Northgate Apartments Phase II

EARLY DESIGN GUIDANCE - 2ND MEETING
NOVEMBER 5, 2018
PROJECT #3030779

BOARD COMMENT SUMMARY (EDG 1; AUGUST 6, 2018)

2G EASEMENT TRASH ROOM LOCATIONS AND SPU ACCESS

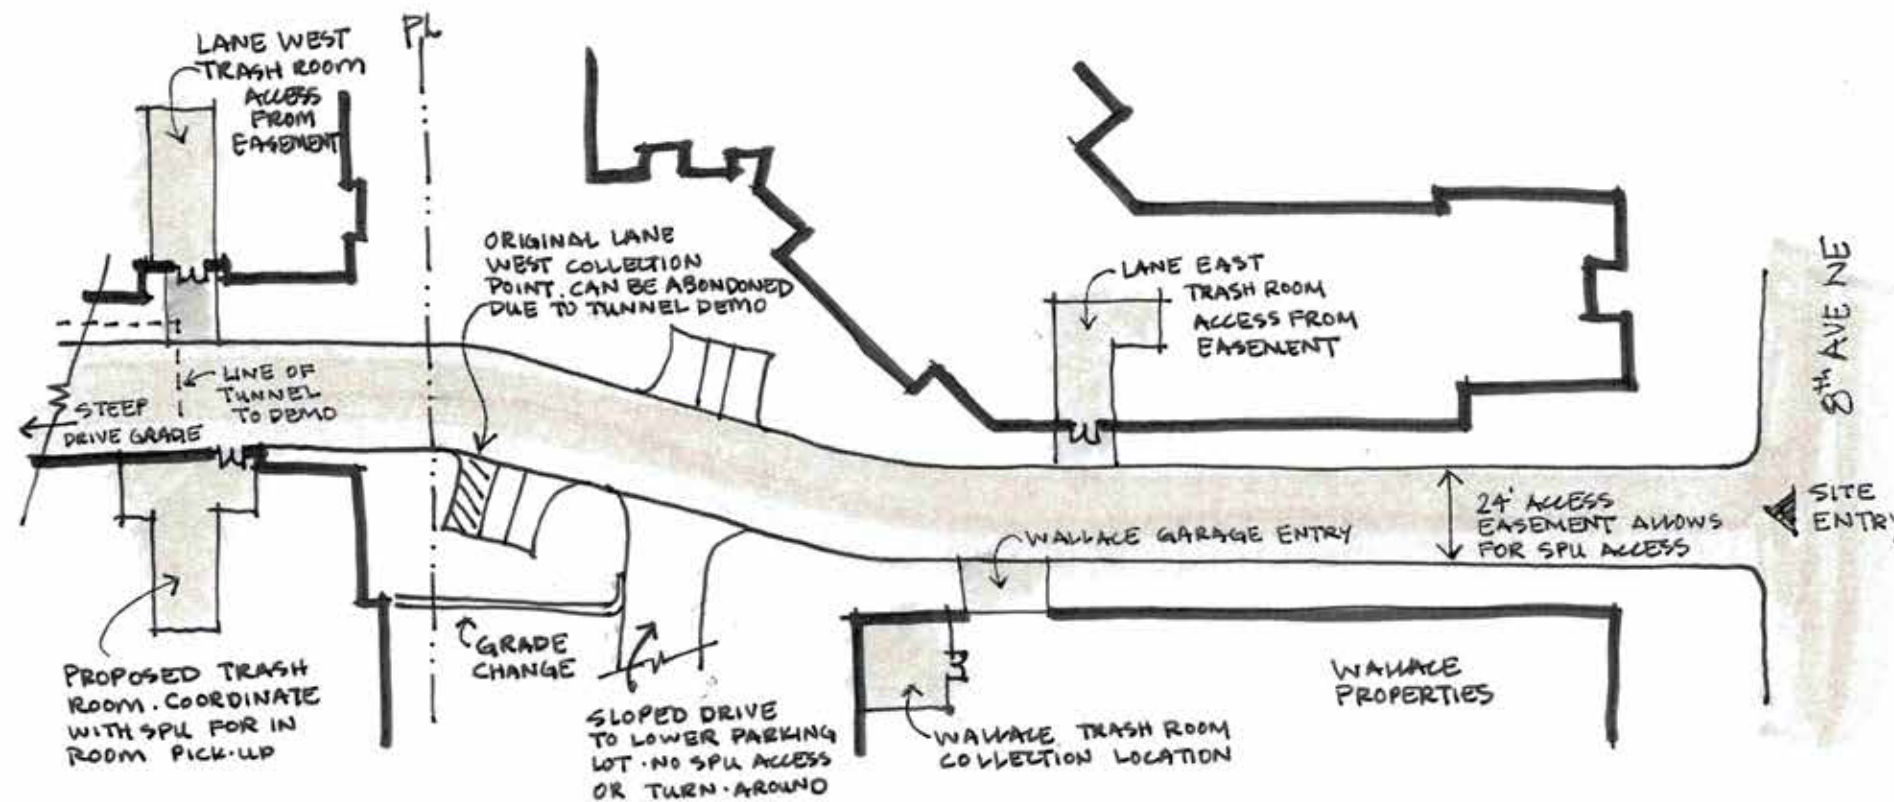
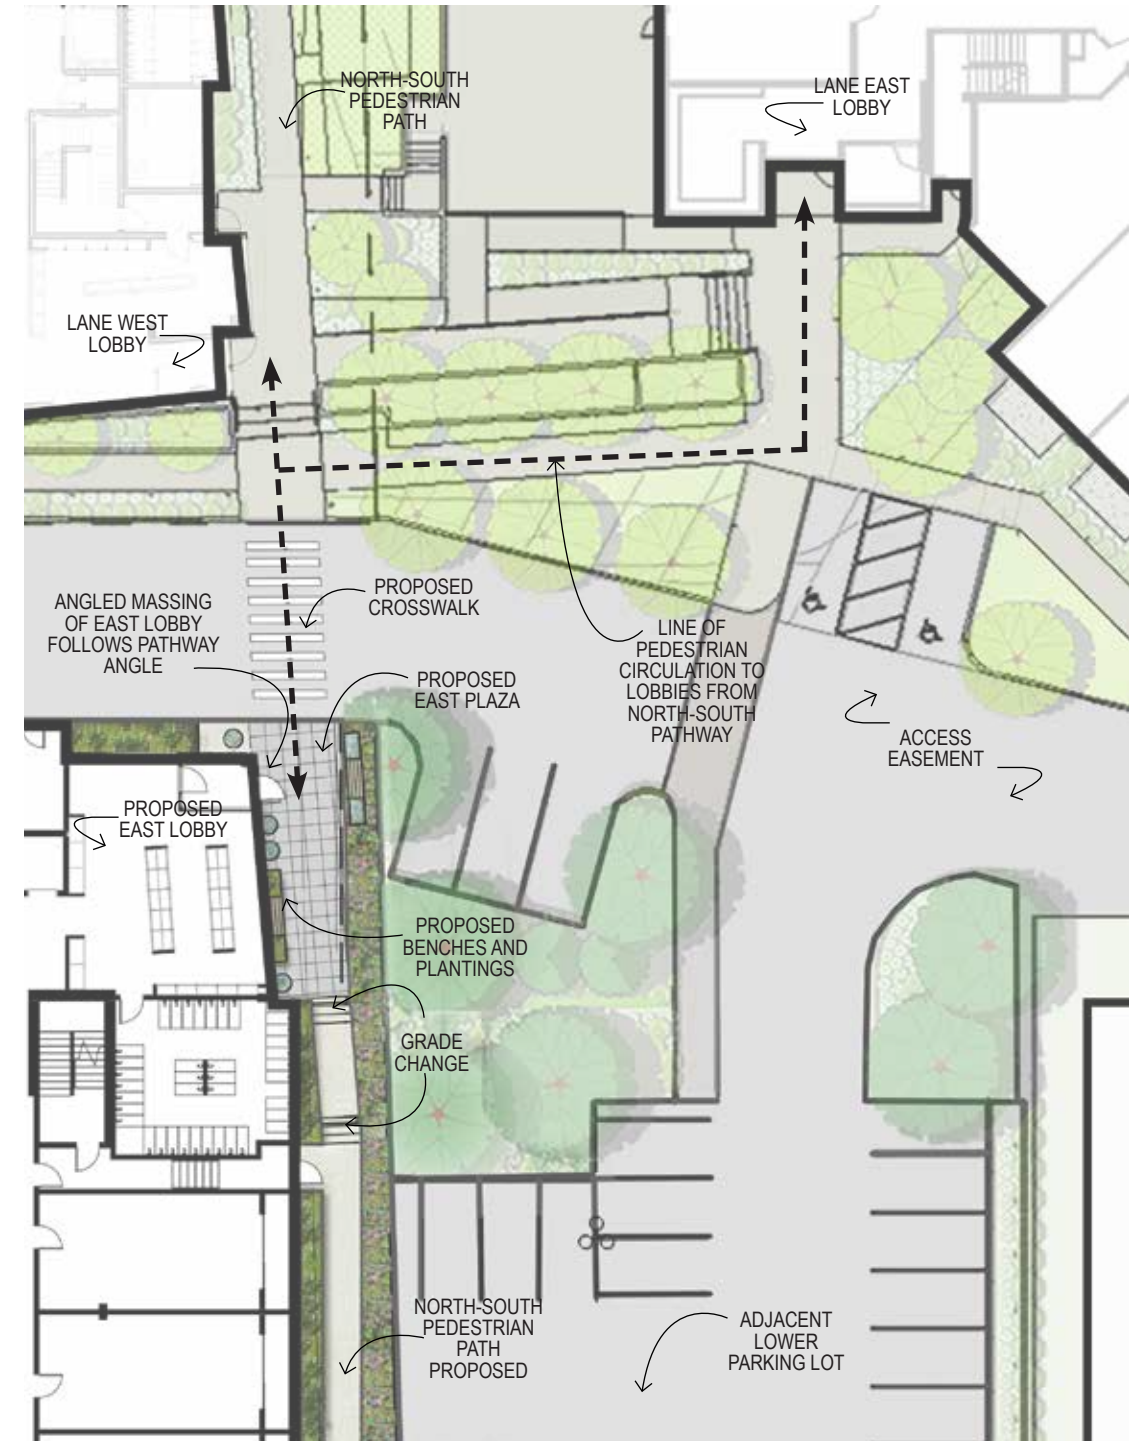
2F The mid-block north/south pedestrian connection established with Lane Apartments and other developments to the north was discussed and the Board recommended the proposal continue this pedestrian connection along the eastern property line and further develop the entry court at the secondary lobby, complementary to the mid-site plaza of Lane Apartments. (PL1-II, PL3-I)

2G The Board was concerned that the trash storage and staging location was harmful to the pedestrian experience and requested study of other locations. (DC1-C, PL3-I)

RESPONSE: The project maintains its proposal to continue the established North-South pedestrian pathway for the full length of its Eastern facade as depicted in the exhibits added in this packet. The lower level massing of Lane Apartments follows the angle of the pedestrian connection with access to the Lane's amenity spaces and its East Building lobby from this pathway. The proposed project responds architecturally by maintaining the same angle parallel to the pathway to relate both entries and encourage pedestrians to continue along this path, arriving at the new East lobby. A crosswalk across the easement will be provided for safety. The proposed project's lobby will be accessed from the pathway, with the path stepping down, following the existing 4' grade change, as it passes dwelling units with recessed decks. The path is landscaped on both sides to provide a buffer between pedestrians and the adjacent building and surface parking. The dwelling units feature decks which are approximately 4 feet above the pathway providing privacy for the units and "eyes on the street" for safety and security. Please see the exhibit on sheets 28, 31-32.

RESPONSE: As noted in new exhibits in this packet, the original design of the Lane Apartments did not anticipate a latter phase of development. Negotiations with the neighboring site (the current proposal's site) resulted in a central refuse/recycle collection area that did not substantially alter the existing surface parking stalls (design or count) nor impact pickup by SPU for containers on collection day. The central location shown in the Lane Apartments design represents the location and design as agreed upon by all parties including SPU. The design team is currently working with SPU to investigate in-room pick-up for both Lane Apartments and the proposed project to avoid the exterior staging of trash. It should be noted however that this may be impossible due to the grading of the existing access easement paving since grading at collection areas is strictly regulated by SPU and already determined by the Lane project given that it is nearing completion of construction. The proposed project already locates our in-building refuse/recycling room along the Northern facade with direct access to the roadway. We have investigated the placement of an alternate location at the lower East parking lot which proved infeasible. The lower parking lot is not accessible to SPU trucks and even if it was, the trash room bring located along the Eastern facade would require the staging area would have to be consolidated between both projects which could prove further undesirable.
